SAN FRANCISCO PLANNING DEPARTMENT

MEMO

RE: SDAT Review
Case No. 2014.0011, Address: 1298 Howard
Neighborhood: Central SOMA
Zoning: RCD, WMUG
Area Plan: EN: South of Market, Western SOMA
Block/Lot: 3728/019, 3728/086

The 1298 Howard Street project came to SDAT on October 26th, 2015. Below are SDAT comments regarding this project.

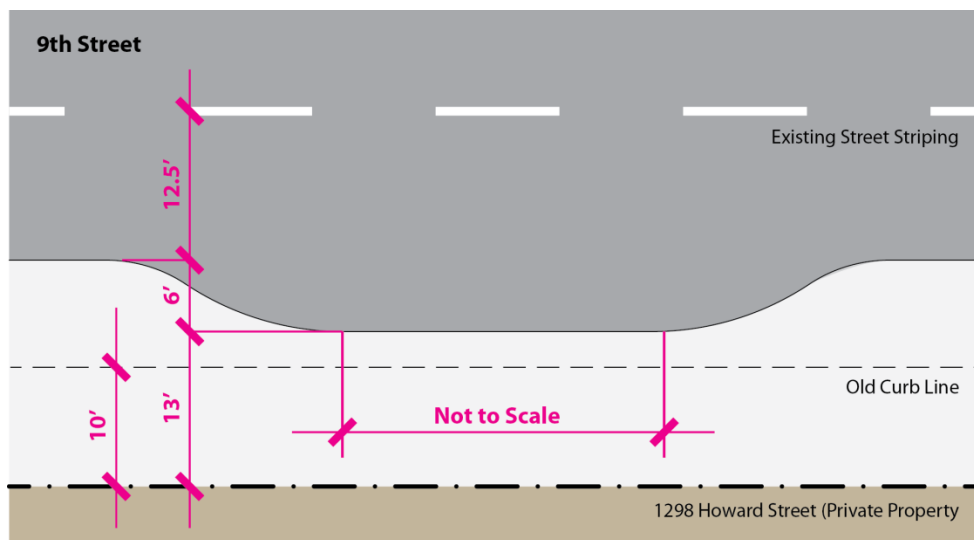
Locating the driveway on Natoma would maximize active ground-floor uses on the larger streets like Howard Street and 8th Street. Furthermore, there are already numerous driveways on this block of Natoma. People driving cars will continue to use it for access, as would this development if the driveway is located on Natoma.

Locating the driveway on Natoma would also raise potential conflicts and tradeoffs that may impact the safety of people riding bikes. In particular, the buffered bike lane on 8th Street may be negatively impacted, although traffic calming improvements could be made at 8th Street to minimize these impacts. However, more significant conflicts with bicycles exist on Howard Street, which is the primary westbound bike route across all of SOMA and is slated for significant upgrades to the bicycle facility located there. SDAT recommends reducing parking to help alleviate potential conflicts.
